## Differences in FM25160 and FM25C160

### 16K SPI FRAM Devices

**Figure 1. FM25160 Single Byte Write**

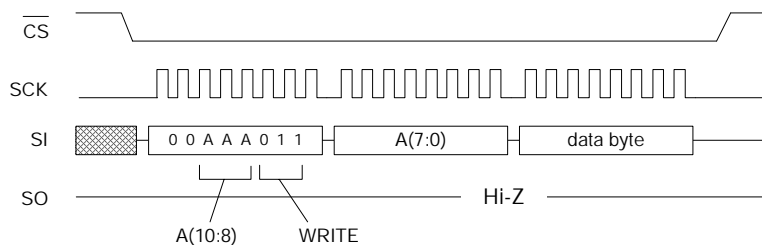
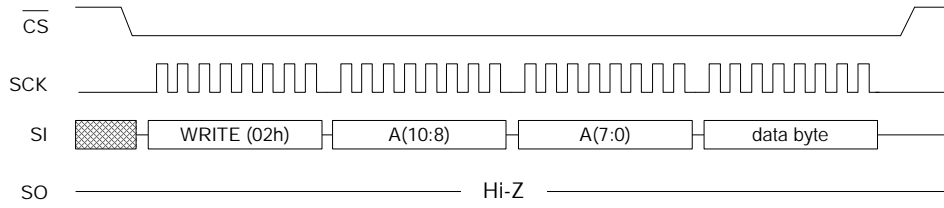
Although packaging and pinouts are compatible, the FM25C160 is not a direct replacement for the FM25160 since the system firmware is not compatible between the two. For example, a single byte write is three bytes for the 25160 and four bytes for the 25C160, excluding the WREN op-code.

**Figure 2. FM25160 Single Byte Read**

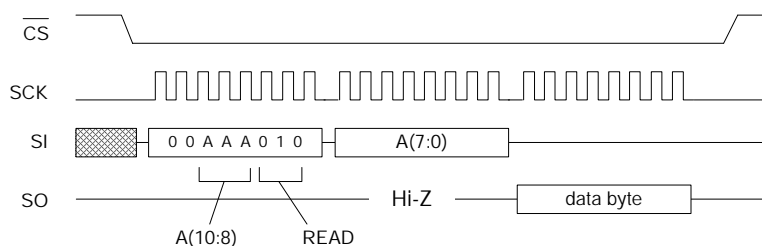
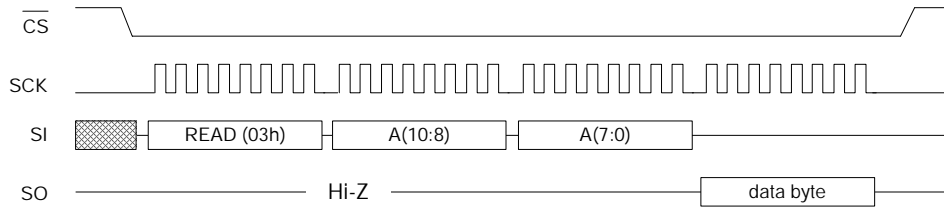
There are differences between the FM25160 and FM25C160 SPI 16Kb FRAM devices. The FM25160 operates up to 1.8MHz and supports Mode 0 clocking, whereas the FM25C160 operates at speeds up to 20MHz and supports Modes 0 and 3. The biggest difference between the two parts is one of addressing. Both parts require an 11-bit address for read and write op-codes, but the original 25160 uses one-byte addressing whereas the newer 25C160 uses two-byte addressing. The 25160 places the upper 3 address bits into the op-code.
